**ADDENDUM FOR
IMPROVEMENTS TO
THE MUNICIPAL ELECTRICAL SYSTEM
FOR THE
CITY OF PIQUA, OHIO**

ADDENDUM NO. 2

CONTRACT NO. 012-01531-00 – POWER PLANT WATERFRONT REDEVELOPMENT PROJECT

**SITE DEMOLITION
PLAN**

DRAWING NO: **C100**

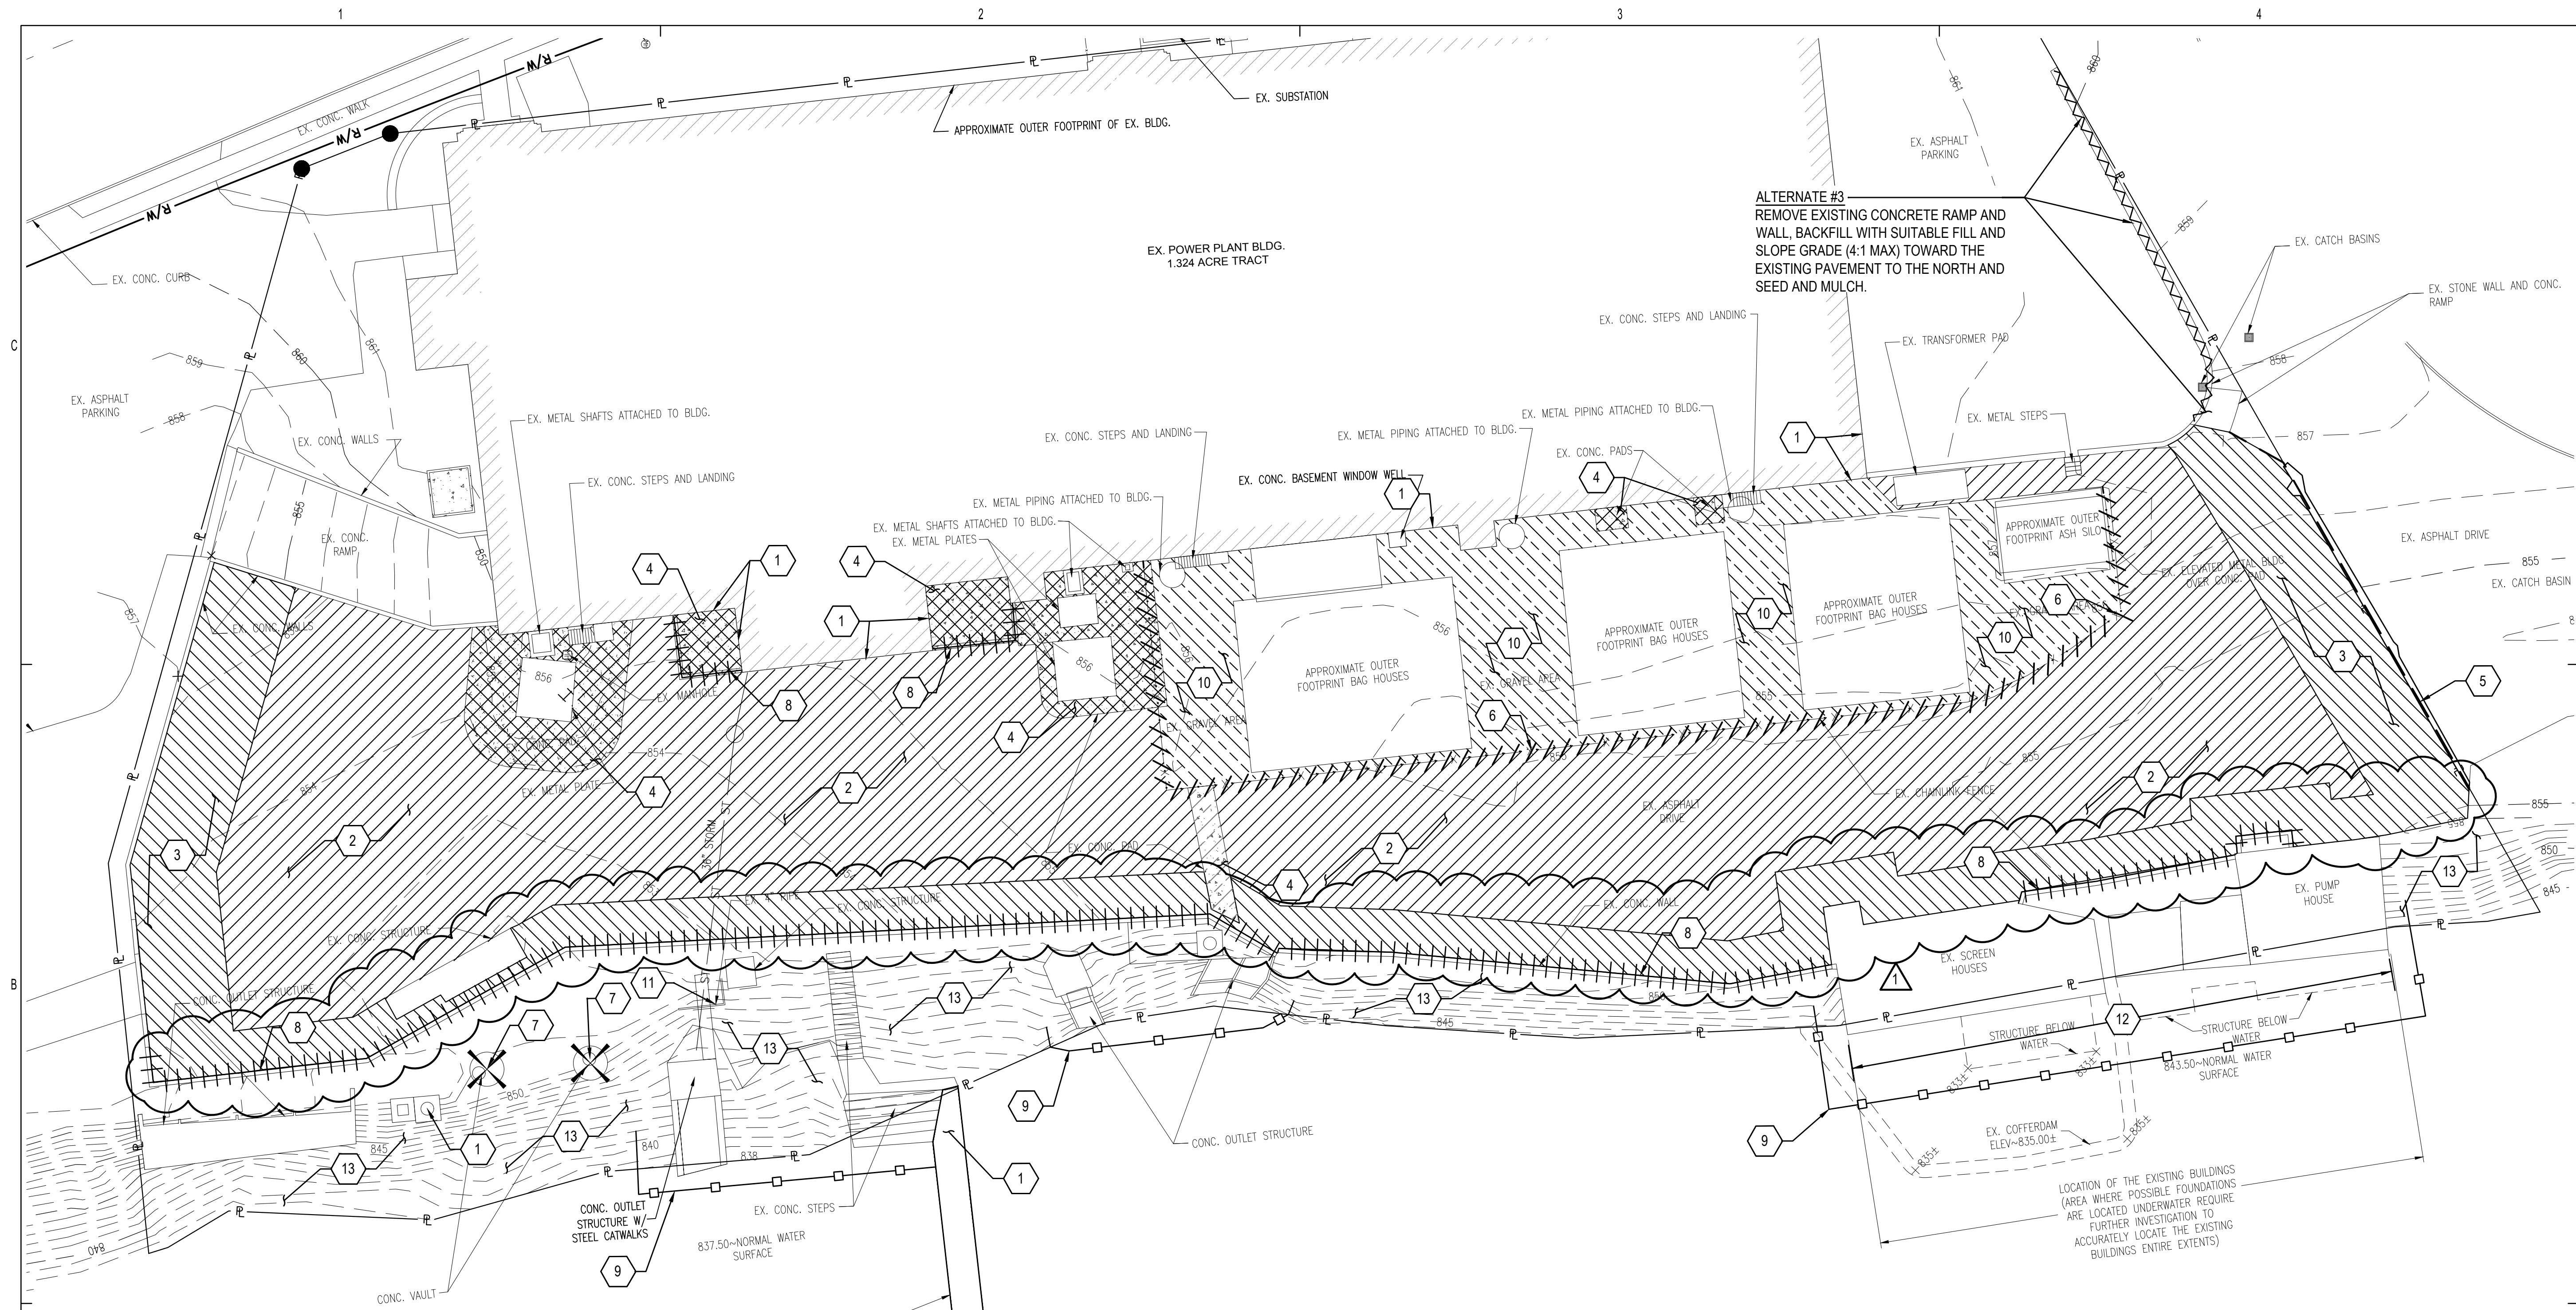
1. Drawing C100 has been revised and is attached to this addendum. This drawing is now Drawing C100 Revision 1. This drawing has been revised to show additional areas that will require additional excavation beyond the existing asphalt. Additional excavation will be required to match the proposed grades while also assuring that at least two feet of clean fill is installed across the site.

2. On drawings C010 and C100 an existing coffer dam is shown east of the existing pump house/future scenic overlook. A bidder has asked if this coffer dam exists and what are the materials of construction of this coffer dam.

Response: The bidders shall assume that the coffer dam does exist and that it is constructed of reinforced concrete.
